LICENSEE: Niagara Mohawk Power Corporation
FACILITY: Nine Mile Point Nuclear Station Unit No. 1
SUBJECT: MEETING SUMMARY REGARDING THE JULY 15, 1991, MEETING TO DISCUSS
LICENSEE'S MAY 14, 1991, SUBMITTAL REGARDING TORUS WALL THINNING
AT NINE MILE POINT 1

July 15, 1991 Meeting to Discuss Licensee's May 14, 1991 Submittal
Regarding Torus Wall Thinning at NMP-1

NMP1 TORUS QUESTIONS FOR
JULY 15, 1991 NRC MEETING

PERMISSIBLE CORRODED THICKNESS
FOR THE TORUS CROSS-SECTION AT MID-BAY
(FREE SHELL REGION)
NINE MILE POINT UNIT 1 NUCLEAR STATION

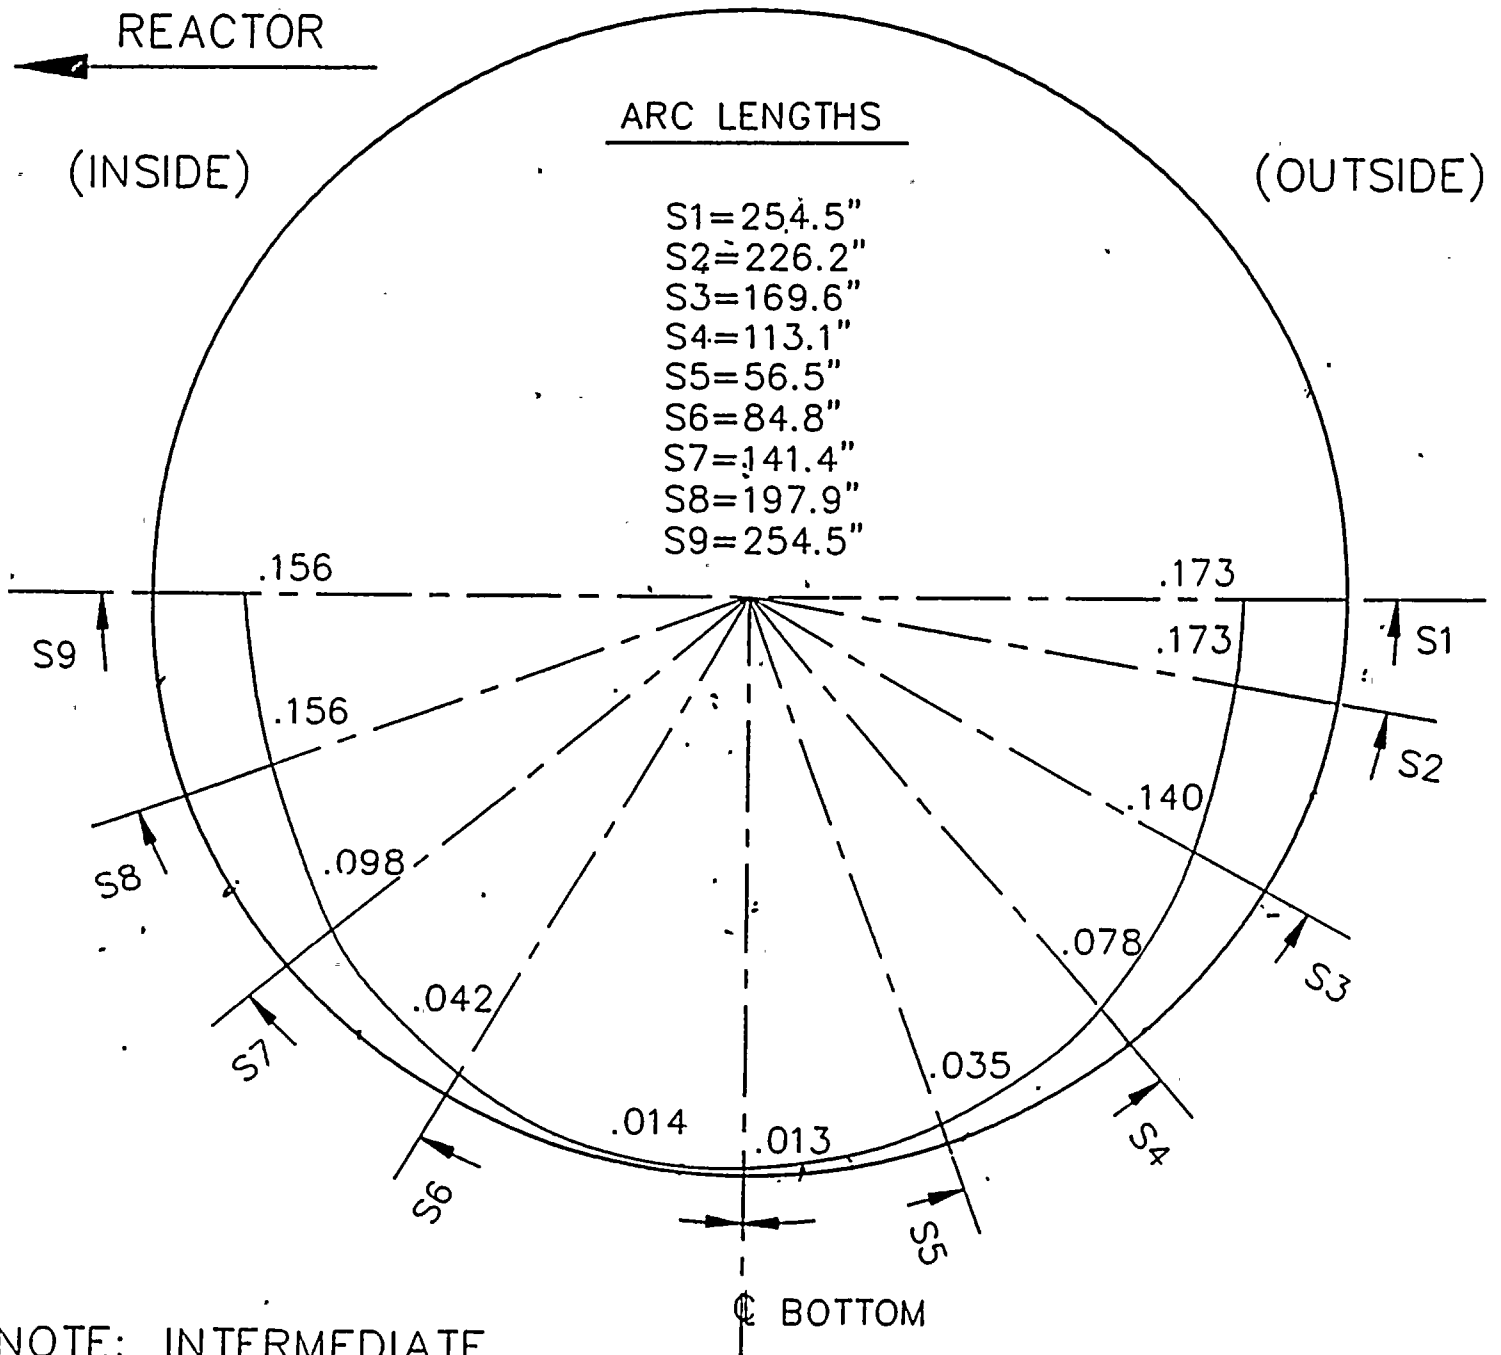
2. In the summary of controlling shell stresses on page 13, stresses for membrane and bending are listed. Indicate if the stresses for bending are from the bending of the torus as a beam or from the bending of the torus shell. If it is the bending of the torus as a beam, the stresses for bending should be considered as primary membrane stresses.
